# Headlamp levelling requirements

## UNECE Regulation 48

### Superimposition of current R48 requirements and proposal

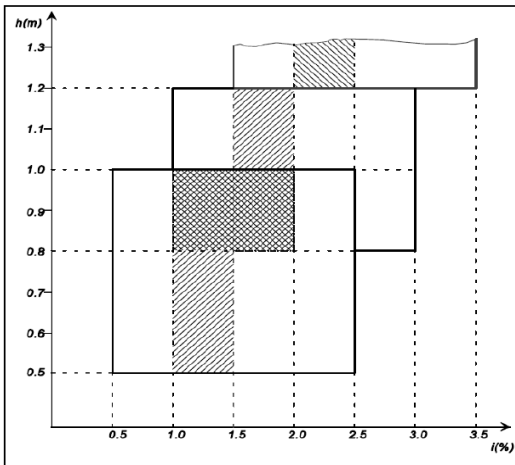
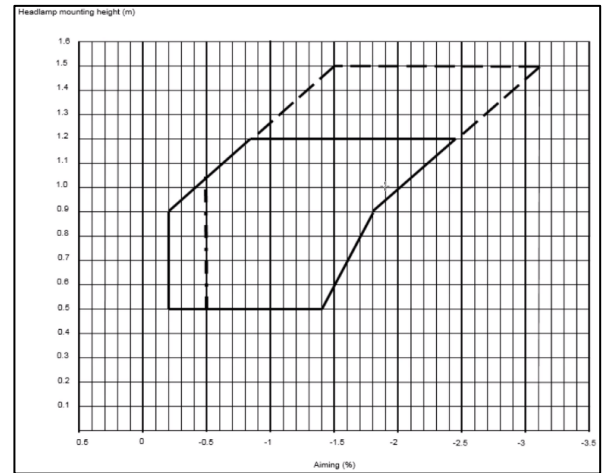
Current

Proposal

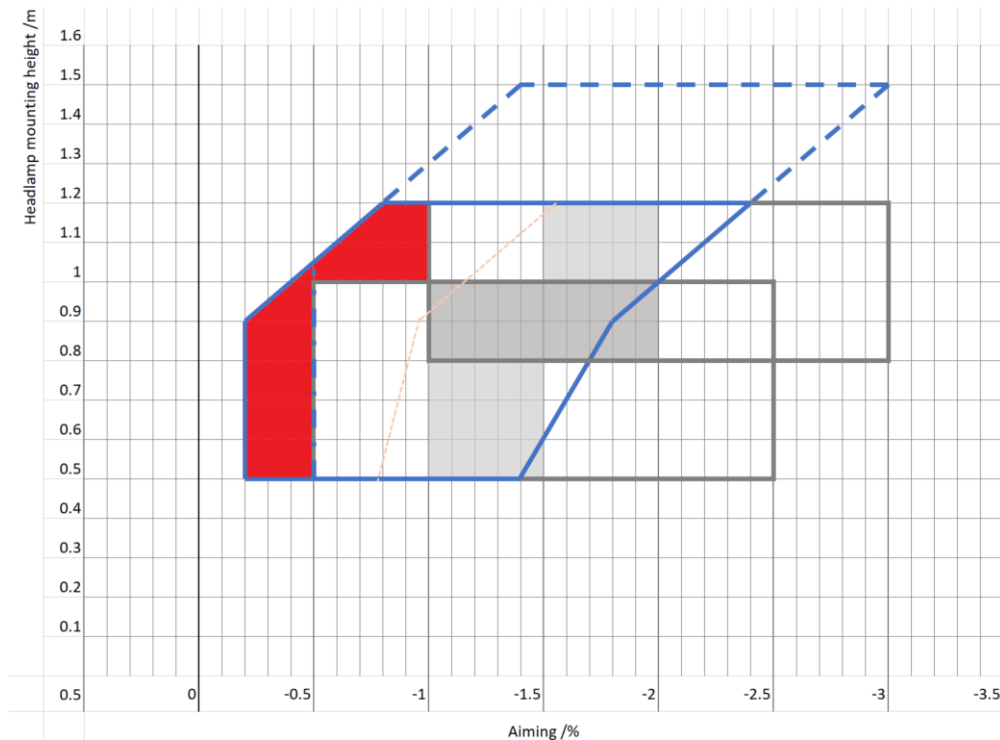
Superimposing both current and proposed R48 requirements on the same graph demonstrates the differences between the two sets of criteria.

The **orange** line outlines the mid-point of the new requirements which could reasonably be considered as the nominal headlamp aim initial set point for vehicles.

Vehicles compliant with the current requirements are in circulation on public roads across the globe and road users have raised concerns over glare caused by oncoming and following traffic.

It is reasonable to suggest that permitting vehicles headlamp aim to move further across to the left into the **red** zone during approval has the potential to increase the occurrence of glare in real world conditions on the road even though rudimentary theoretical representations suggests otherwise.

The increased potential for glare undermines the motivation for amending the headlamp aim criteria in line with the proposal. Therefore, the possibility of a phased approach to amending aim criteria should be considered.
